Salem December 2014 NRC Exam

Question RO#61

GLENN CW DELTA T (RUN ON 12/22/2014 10:32:37 AM)

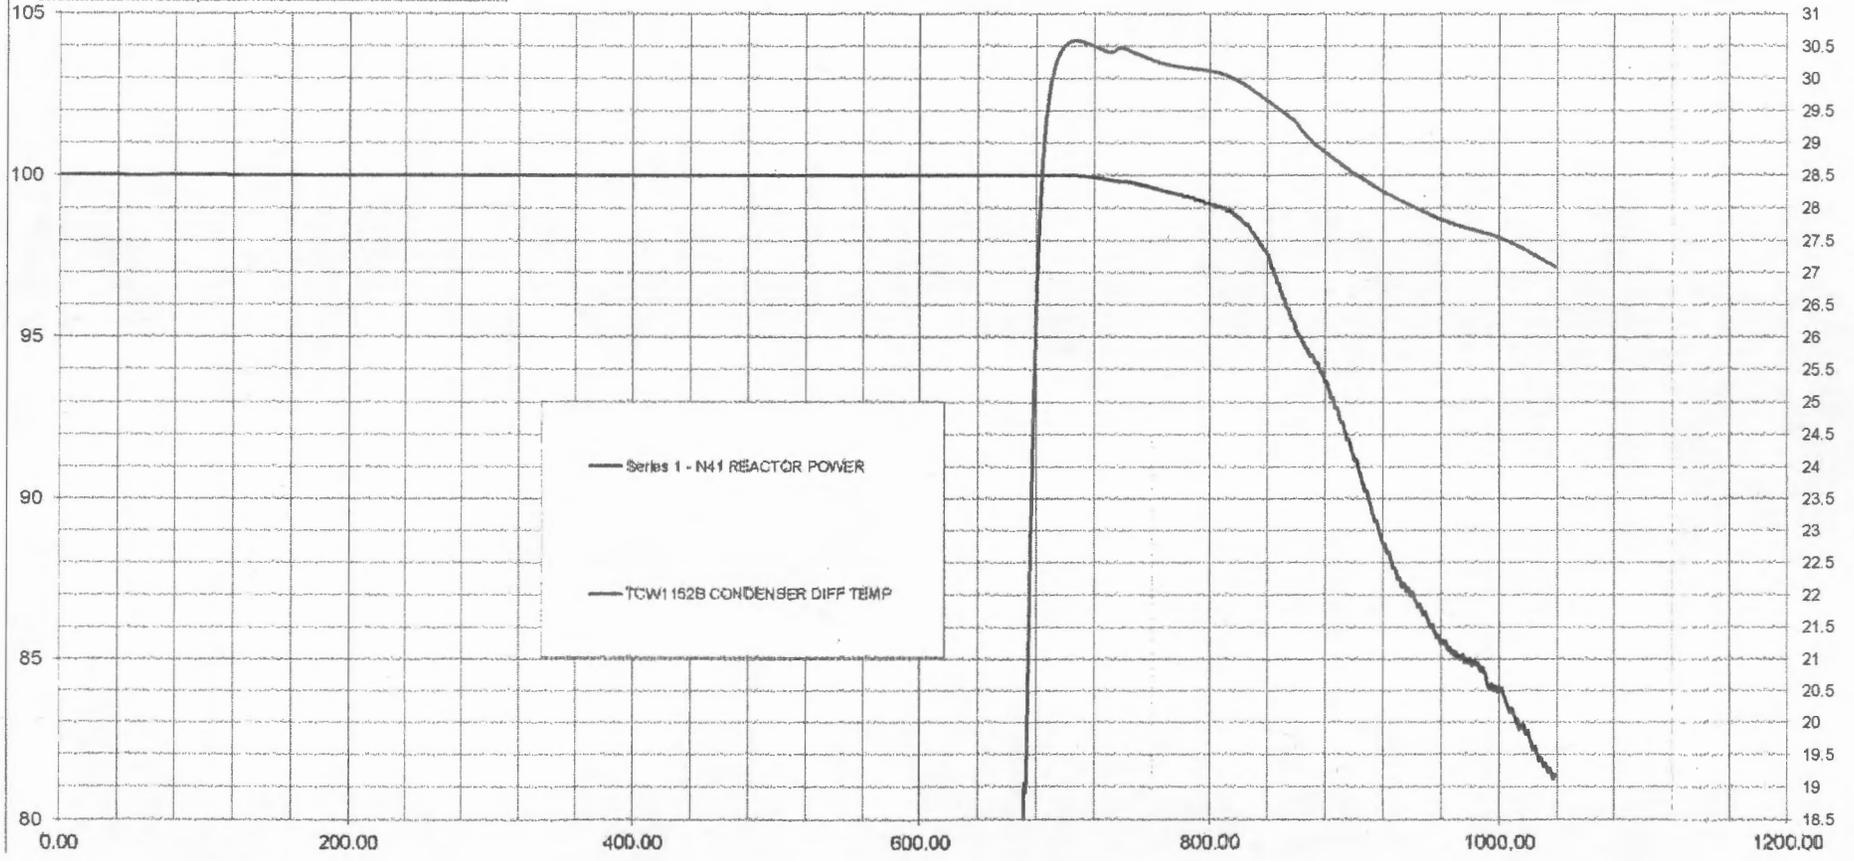
Based on their knowledge of plant response to a loss of circulators, 4 of 8 SRO candidates assumed that condenser ΔT would rise rapidly and exceed the 27°F limit, and based their answer on having to do a rapid load reduction to some power level below 83%. The accompanying simulator charts reflecting a breaker failure on the 2-6 500KV breaker corroborates that rapid rise in condenser temperature, and the necessity for initiating the power reduction. As shown on the Plant Computer screen shot, Rx power was lowered to approximately 81% to reduce Condenser ΔT to 27.1°F. An additional simulator computer graph shows that a Rx power reduction to 81% power was required to lower condenser ΔT to 27 °F.

NRC Conclusion: This question was initially acceptable for the examination based upon the (incorrect) premise that the Continuous Action Summary would not come into effect. However, based upon the simulator modeling of condenser delta-T for the given conditions, the NRC concluded that Choice c is a correct response. The NRC will accept Choices c and d as correct responses to this question.

SALEM NUCLEAR GENERATING STATION
NO. 2 UNIT
SERVICE WATER NUCLEAR AREA
MECH./CONT.

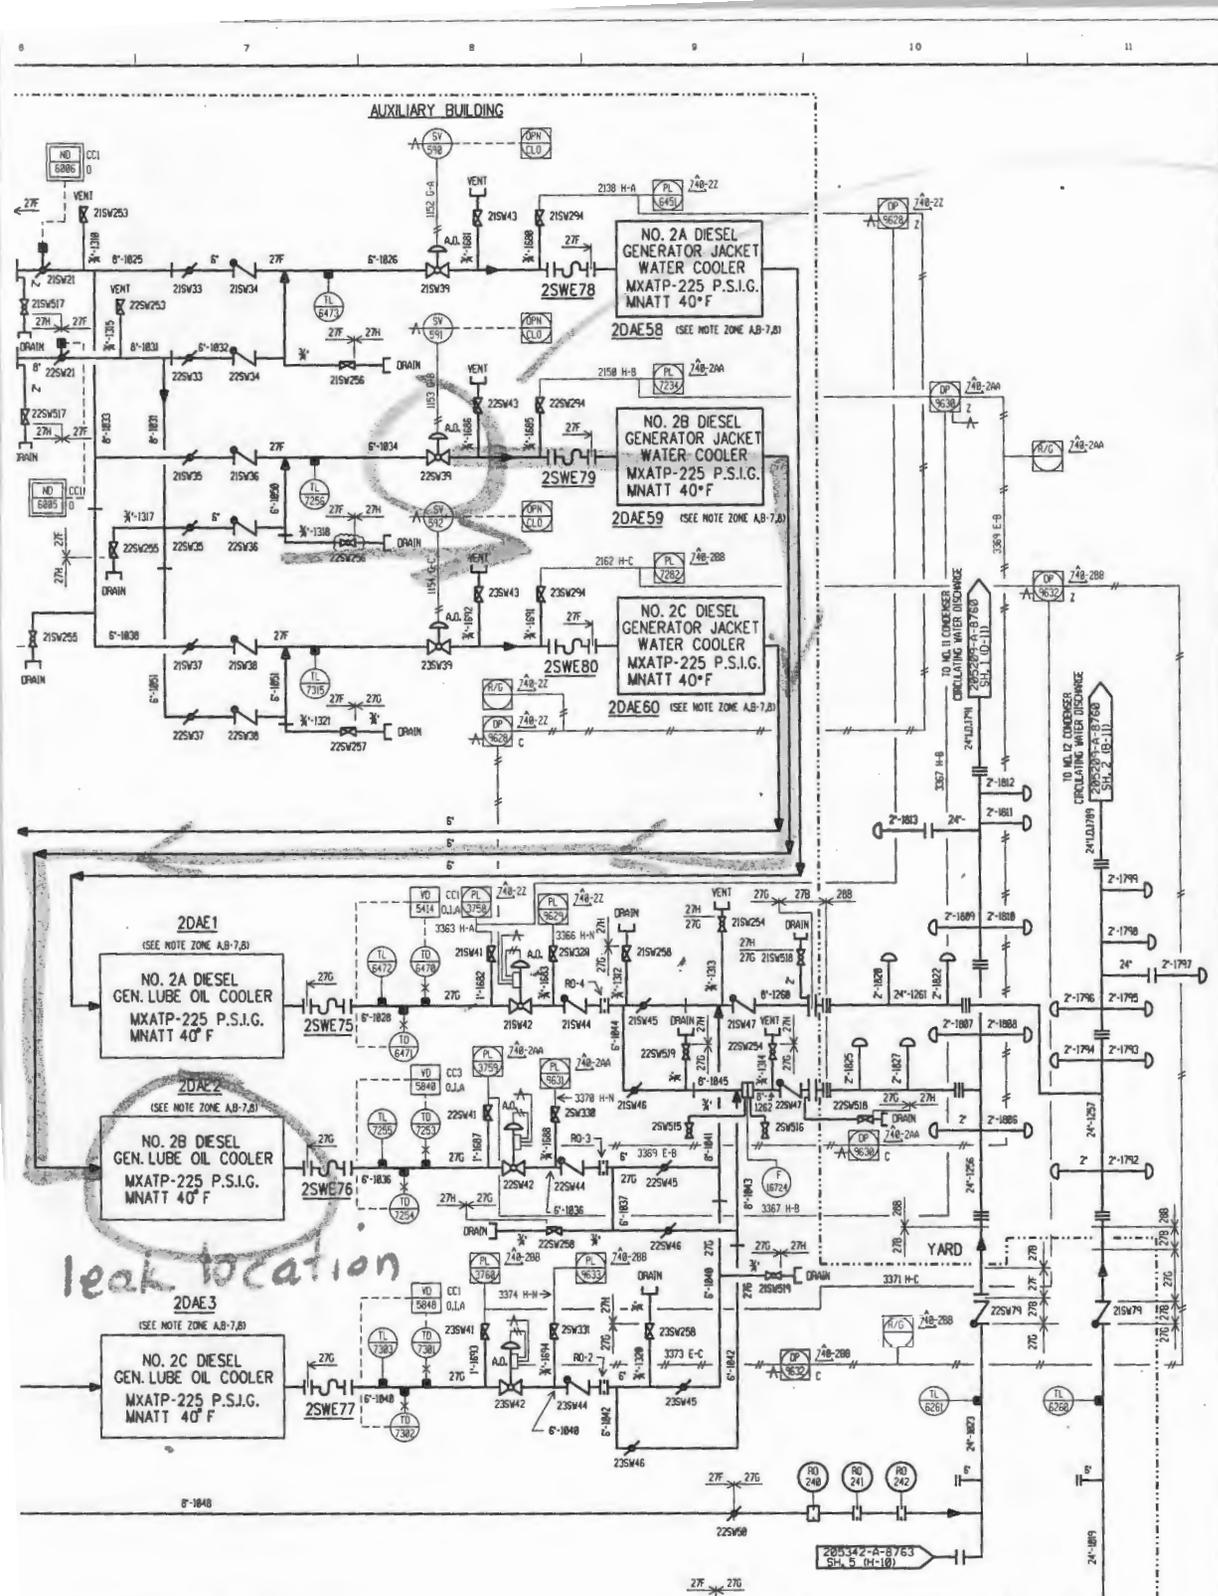
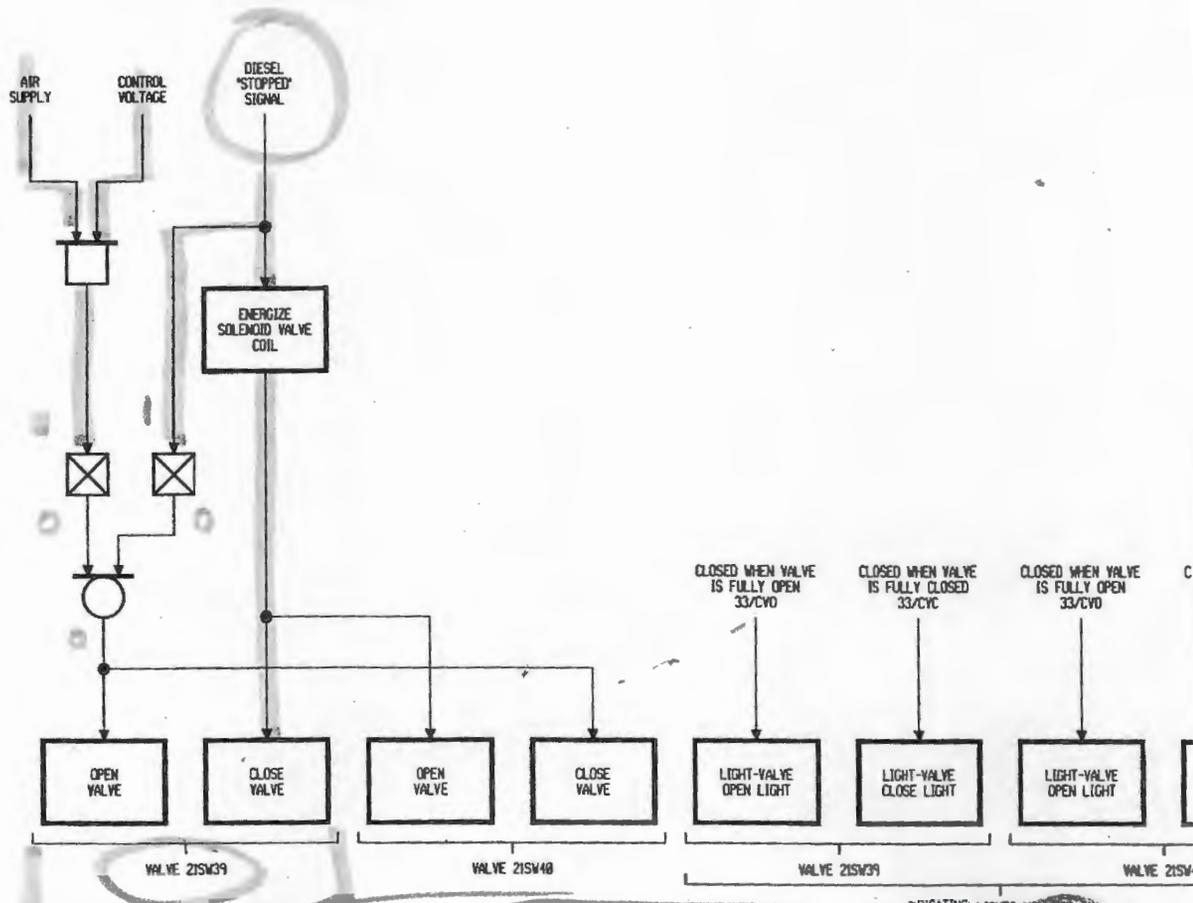
There is no correct answer to question #8. As shown on drawing 205342, Sheet 3, the 22SW39 is the 2B EDG Jacket Water and Lube Oil Coolers SW Supply Valve, which is normally **closed** with the EDG out of service. The 2A, 2B, and 2C EDGs are normally out of service, and no indication was given in stem that 2B EDG was in service. A leak on the EDG Lube Oil Cooler will not reduce SW Header pressure. Drawing 246689 shows that when the EDG is stopped the SW39 is demanded closed and does not go open until the EDG is started. There is an additional choice (b), which also had a leak location on a line which is normally out of service, so it cannot be assumed that the leak location was active.

with
225W39-X
(normal position)
2B EDG LO
cooler leak
would be
invisible in
control room.

leak location

NRC Conclusion: This question was initially acceptable for the examination based upon the (incorrect) premise that the service supply header isolation valves (SW39s) were in the open position. However, based upon the plant conditions provided in the question, and documentation supporting that these valves would have already been closed, The NRC concluded that Choice c is incorrect. The NRC will delete this question based upon the determination that there is no correct answer.

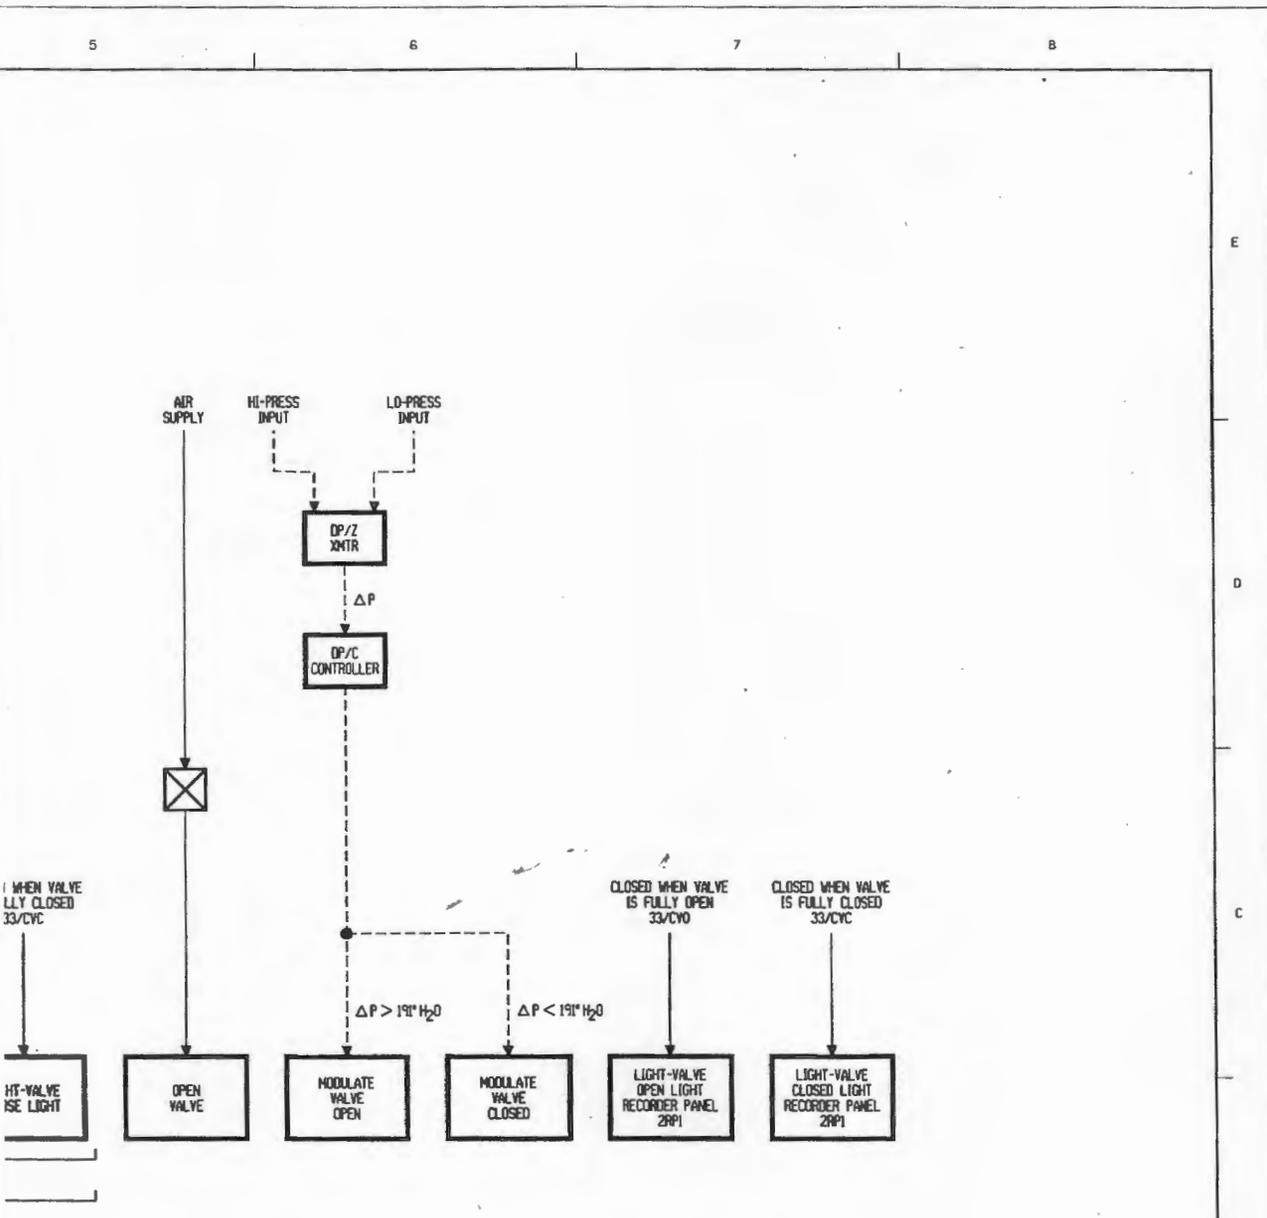
SRO Q8

Licensee Recommendation: The licensee proposed to delete this question based upon there is no correct answer. For the given plant conditions (no emergency diesel generators running), the service water supply header isolation valves (SW39s) would already be closed. These valves are normally closed and are open if their respective EDG is running. Therefore, if a leak developed on the 2B EDG Lube Oil Cooler (Choice c), it would not reduce SW header pressure because the oil cooler is already isolated. The proposal to delete this question is based up the SW flow path on Drawing 205342 Sheet 3 and the valve control logic on Drawing 246689.
